# REQUEST FOR COUNCIL ACTION

AGENDA SECTION: PUBLIC HEARING	ORIGINATING DEPT: PLANNING	ITEM NO. <b>E-12</b>
ITEM DESCRIPTION: Final Plat #03-03 by Century Point LLC to be known as Century Point First. The applicant is proposing to subdivide approximately 10.57 acres of land into 34 lots for single family residential development. The Plat also proposes to dedicate right-of-way for new public roadways. The property is located along the east side of East Circle Drive (CR 22), north of Silver Creek Road at the East Circle Drive entrance to the Century Hills development.		PREPARED BY: Theresa Fogarty, Planner

**TO:** Rochester Common Council  
**FROM:** Theresa Fogarty, Planner  
**DATE:** August 13, 2003  
**RE:** Final Plat #03-03 by Century Point LLC to be known as Century Point First. The applicant is proposing to subdivide approximately 10.57 acres of land into 34 lots for single family residential development. The Plat also proposes to dedicate right-of-way for new public roadways. The property is located along the east side of East Circle Drive (CR 22), north of Silver Creek Road at the East Circle Drive entrance to the Century Hills development.

**RE:** **CENTURY POINT FIRST

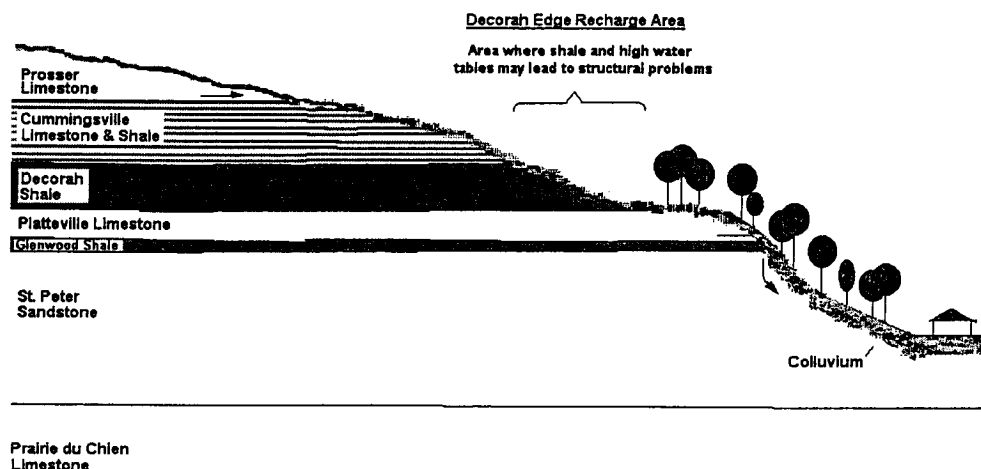
The Decorah Edge (see diagram below) is present within the area where the parcel is located. In this hydrogeologic setting, water discharges from the upper aquifer through soils overlying the Decorah shale before recharging the underlying aquifer. Developments in this setting have the potential to affect and be affected by these groundwater processes. Shrinking and swelling of the shale may cause structural problems and seasonal high water tables may result in wetness and flooding problems.

This finding is based on information derived from the Olmsted County Geological Atlas, construction logs from nearby wells, and bedrock mapping using two-foot contour intervals. The Decorah shale layer within this area is mapped at elevation of 1118' to 1158', and the Glenwood shale from 1087' to 1093' (see attached map). More accurate bedrock elevations may be available from borings completed on or near the site.
